Service Bulletin

Subject: Delayed Engagement After Sitting With Engine Off - Torque Converter Fluid Drain Back

- A. Old stator support asm
- B. New stator support asm

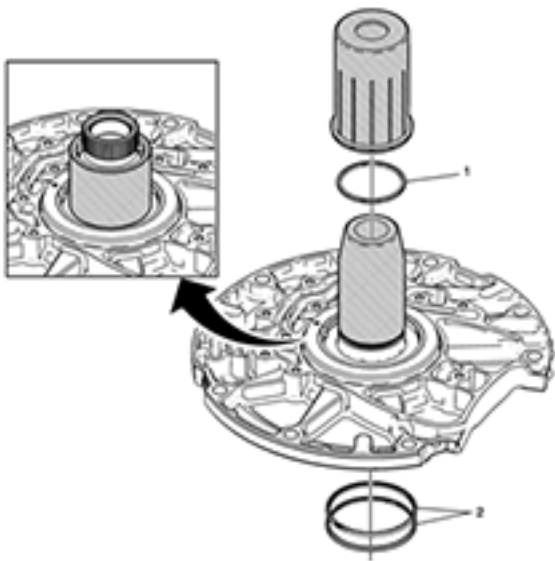
Note: The new stator shaft support assembly has a second check ball (1) added (see illustrations).

Install a new stator shaft support assembly that includes an additional check ball. Follow the instructions below to replace the stator shaft support assembly.

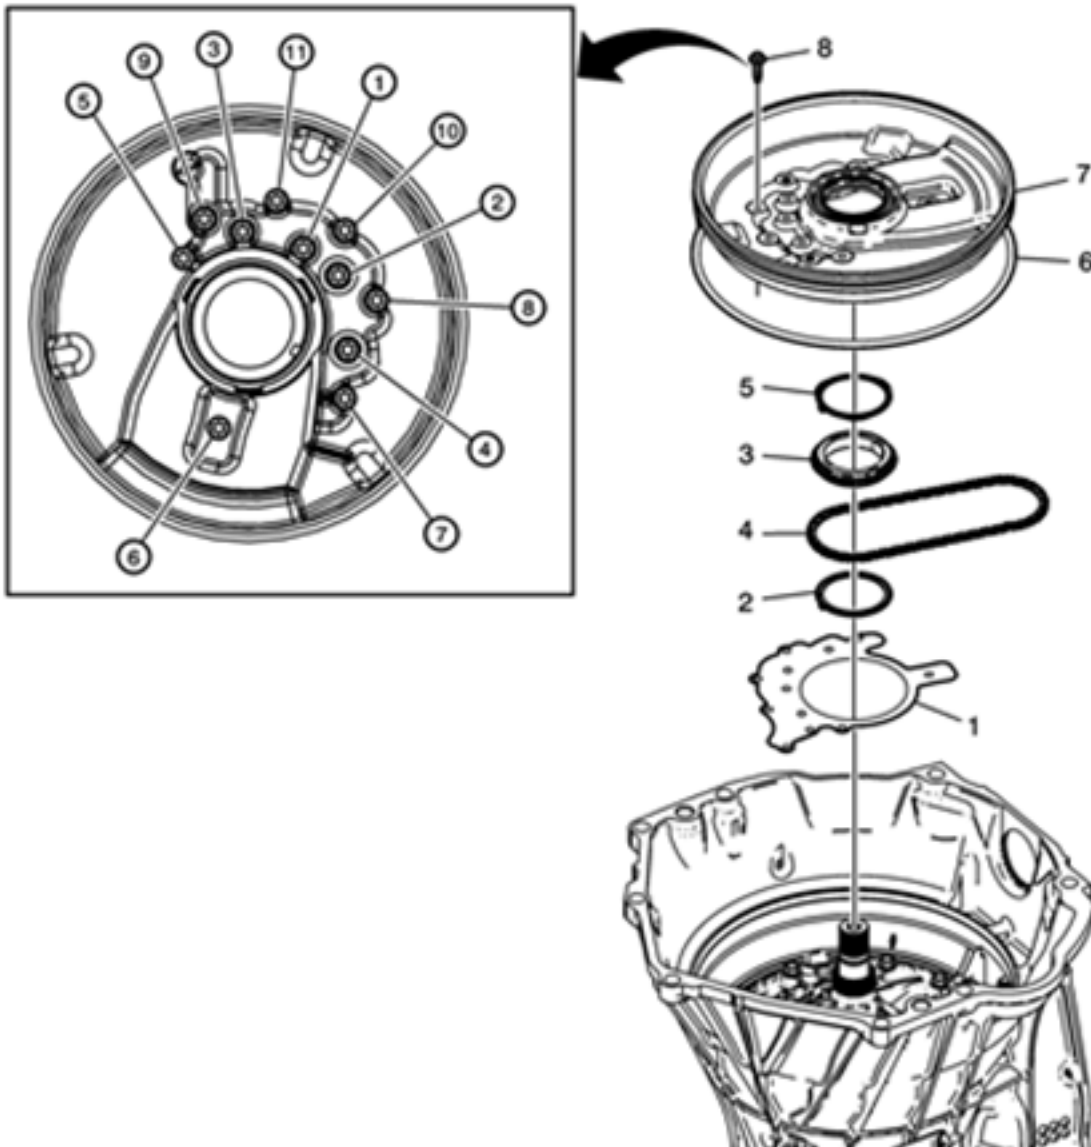
Note: The casting void has been eliminated from the underside of the cover for the 8L90 only (see illustration). The 8L45 is not required.
